DEVIATION REQUEST FORM

Deviation Reference Number	DEV_281	
Date of decision	28/07/2022	
Precedent (YES/NO)	No	
Precedent details	N/A	
Date of submission	01/07/2022	
Project/PoA/VPA	Project	ID – GS567
	<input type="checkbox"/> PoA	ID – GSXXXX
	<input type="checkbox"/> VPA	ID – GSXXXX
Project/PoA/VPA title	Amayo 40 MW Wind Power Project – Nicaragua	
Date of listing	August 27th, 2010 (GS Registration Date) April 12th, 2009 (CDM Registration Date)	
GS Standard version applicable	Gold Standard for the Global Goals	
Date of transition to GS4GG (if applicable)	July 19th, 2021	
Date of transition to Gold Standard from another standard (e.g. CDM) (if applicable)	August 27th, 2010	
Date of design certification/inclusion (if applicable)	August 27th, 2010	
Location of project/PoA/VPA	Nicaragua	
Scale of the project/PoA/VPA	<input type="checkbox"/> Microscale <input type="checkbox"/> Small scale <input checked="" type="checkbox"/> Large scale

Project Amayo I (GS ID 567) requests for its 2nd CP to be 7 years instead of 5 years after switching from GS-CDM to GS-VER, maintaining the on-going 7-year CP cycle under GS-VER stream until expiration (11 Apr 23, year 14 of the project), and at the time

Below a representation graph.

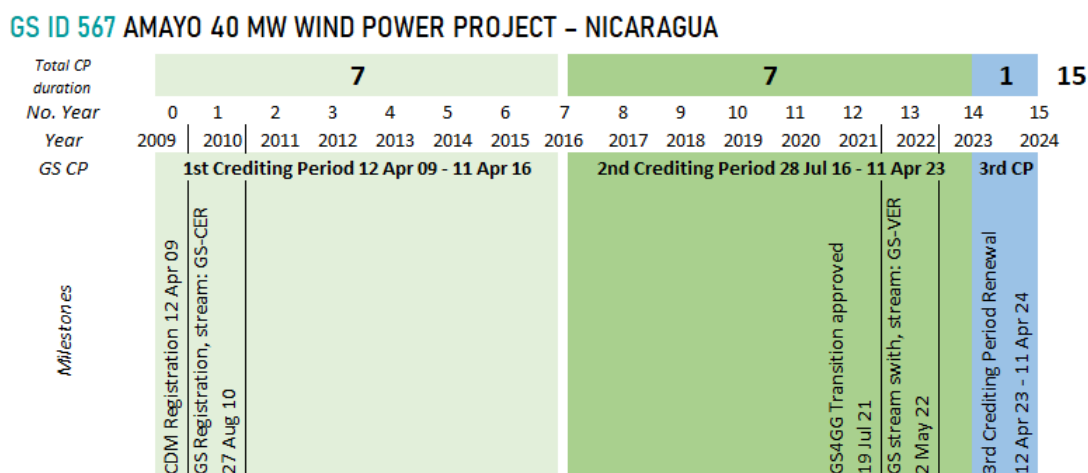
- 1st CP: 12 Apr 09 to 11 Apr 16 (7 years)
- 2nd CP:
 - 5-year CP: 28 Jul 16 to **11 Apr 21¹**
 - 7-year CP: 28 Jul 16 to **11 Apr 23** - Requested under this deviation

The implication for the project under the 5-year 2nd CP cycle (28 Jul 16 to 11 Apr 21) is that the project would not be able to directly claim GS-VER emission reductions from 12 Apr 21 until the 3rd CP renewal (end of 2022 or later), increasing the administrative burden and costs for the project.

Project Amayo I (GS ID 567) requests for its 2nd CP to be 7 years instead of 5 years after switching from GS-CDM to GS-VER, maintaining the on-going 7-year CP cycle under GS-VER stream until expiration (11 Apr 23, year 14 of the project), and at the time of the 3rd CP renewal (12 Apr 2023) align to the

5-year cycle, being aware that this last renewal will only be valid for 1-year (12 Apr 23 – 11 Apr 24) aligning to the 15 years maximum CP stipulated in the Renewable Energy Activity Requirements.

The deviation is not approved.

In-line to para 6.5.1. of Annex B of [GHG Emissions Reduction & Sequestration Product Requirements v.2.1](#) the project transitioned from GS-CER to GS-VER shall follow the GS4GG certification cycle of 5 years.
